TOWN OF LEWISBORO
Westchester County, New York

AGENDA

Tuesday, September 29, 2015

TO: Chairman Jerome Kerner, AIA and
Members of Lewisboro Planning Board

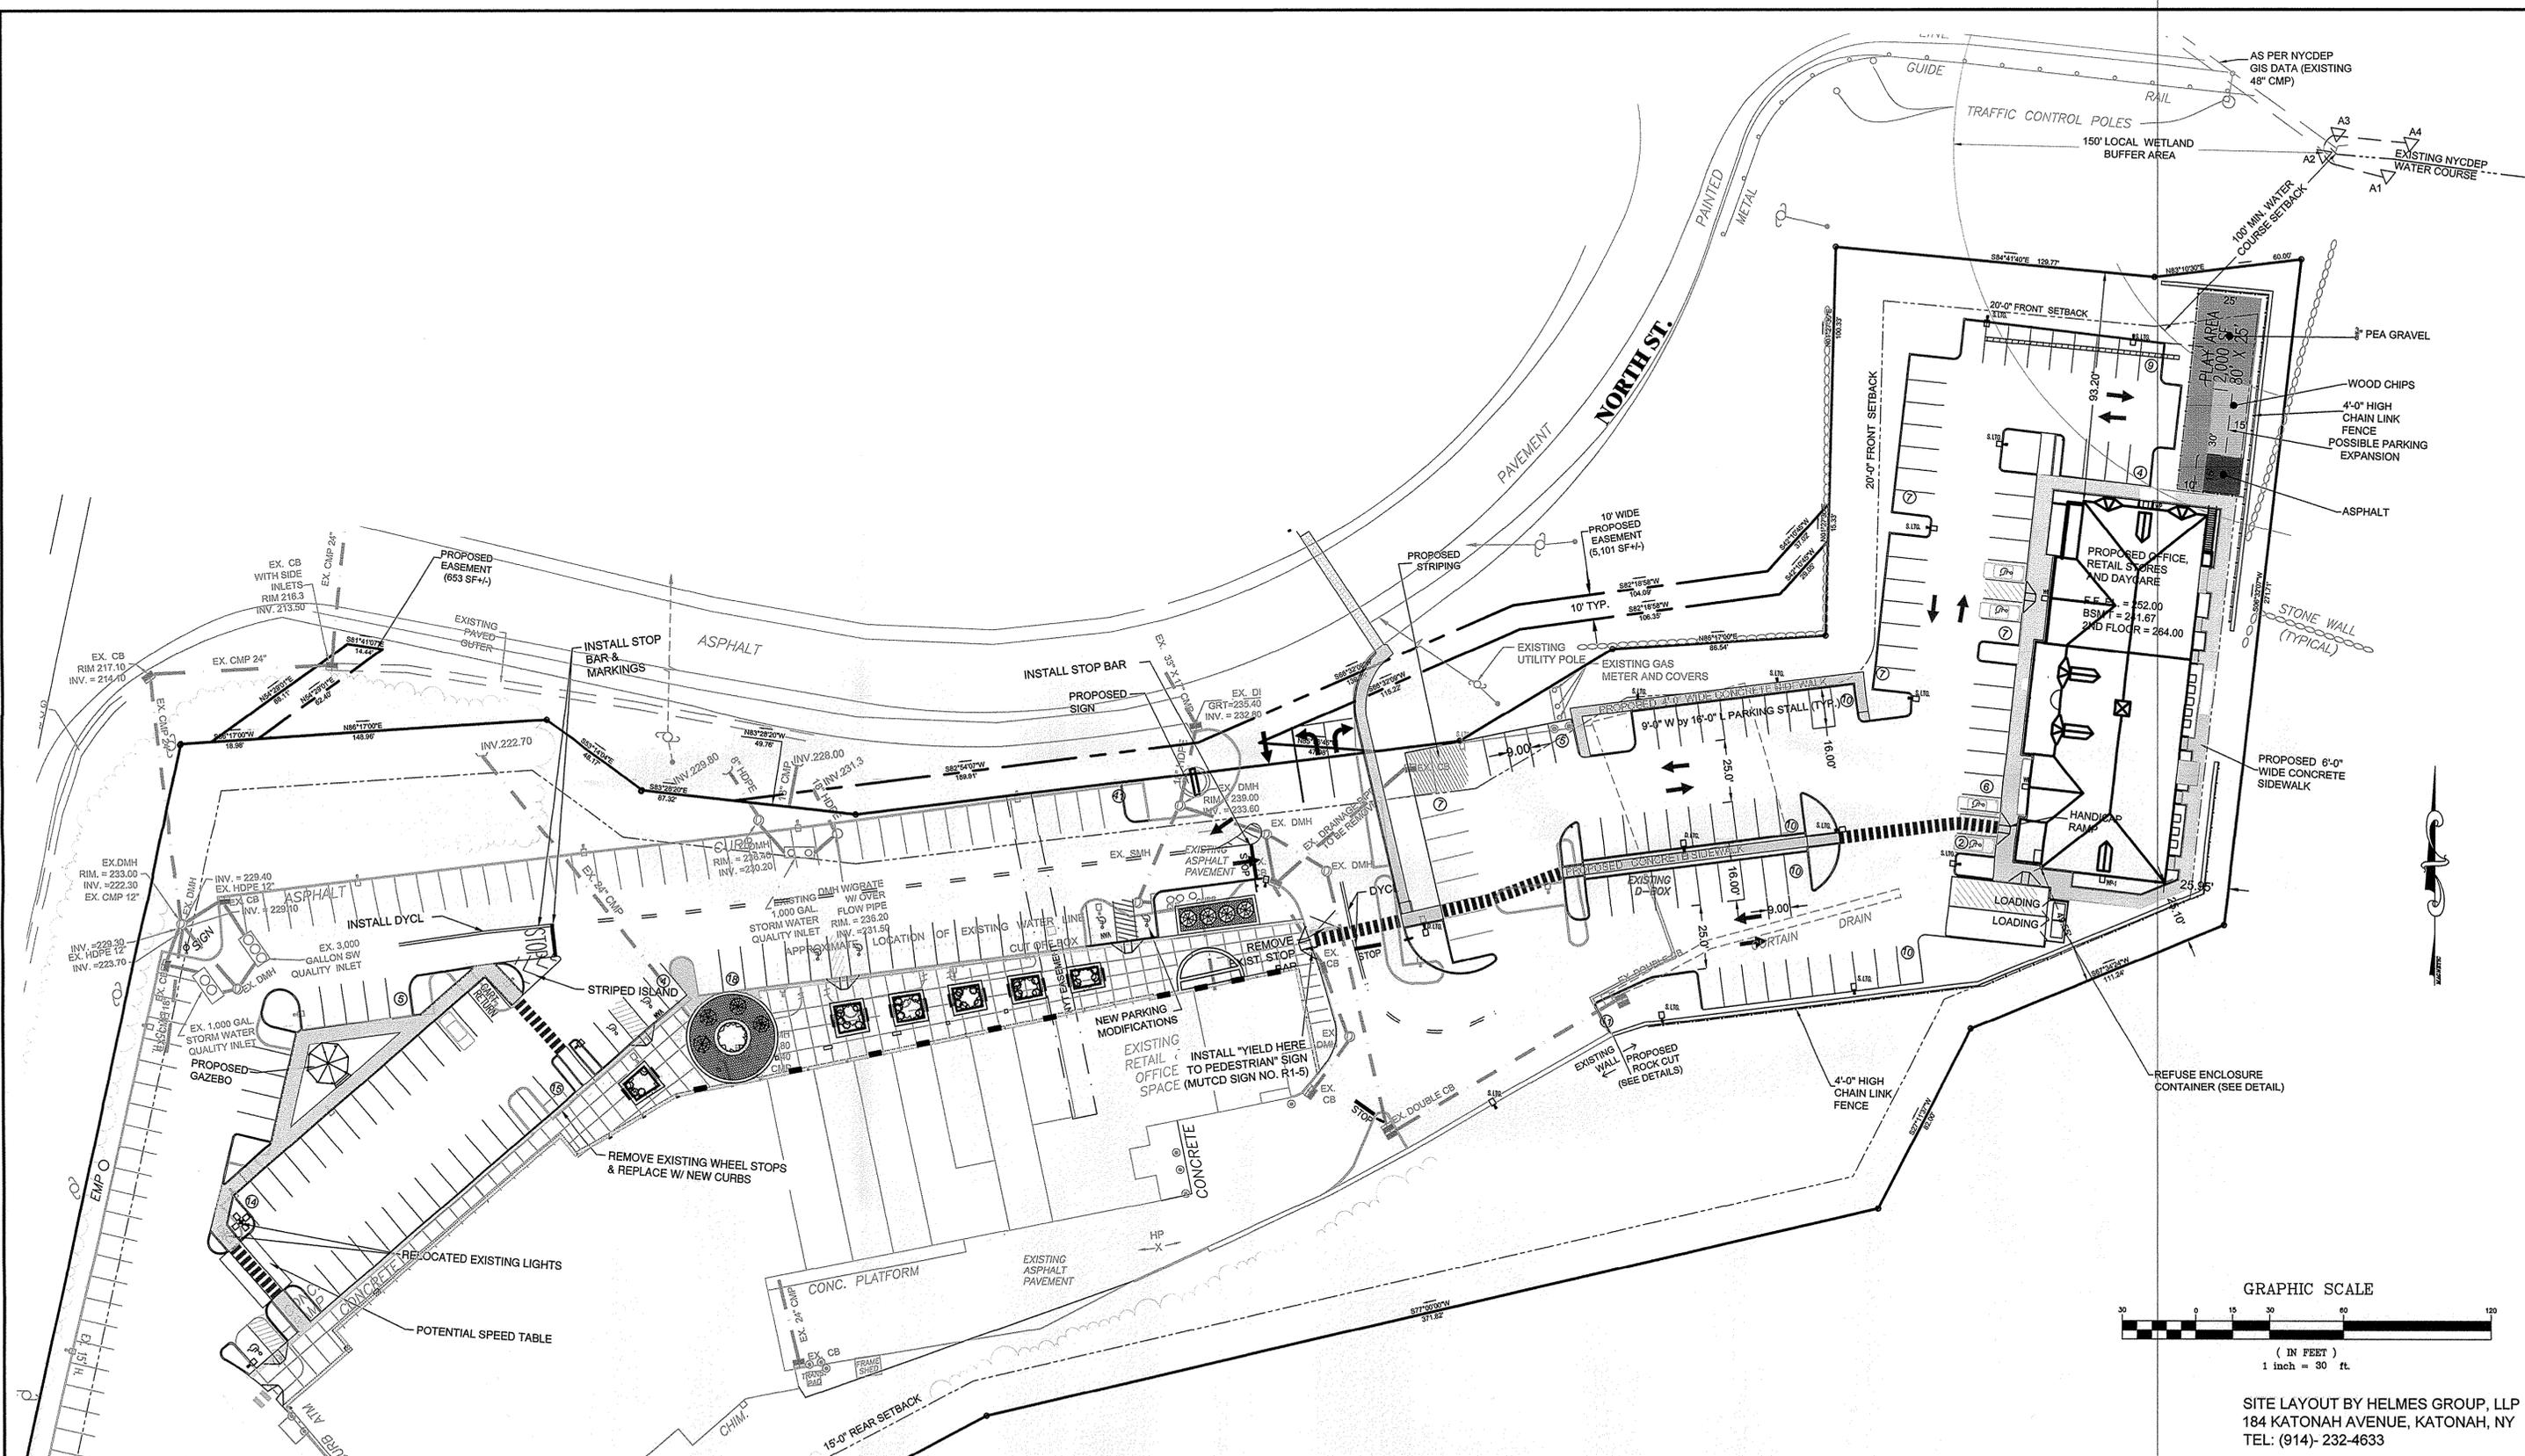
4. The applicant has acknowledged that the State will require the outdoor play area and the site plan has been revised to illustrate this; the Landscape Plan, Sheet LA-1, should also be revised to eliminate the potential parking expansion area.
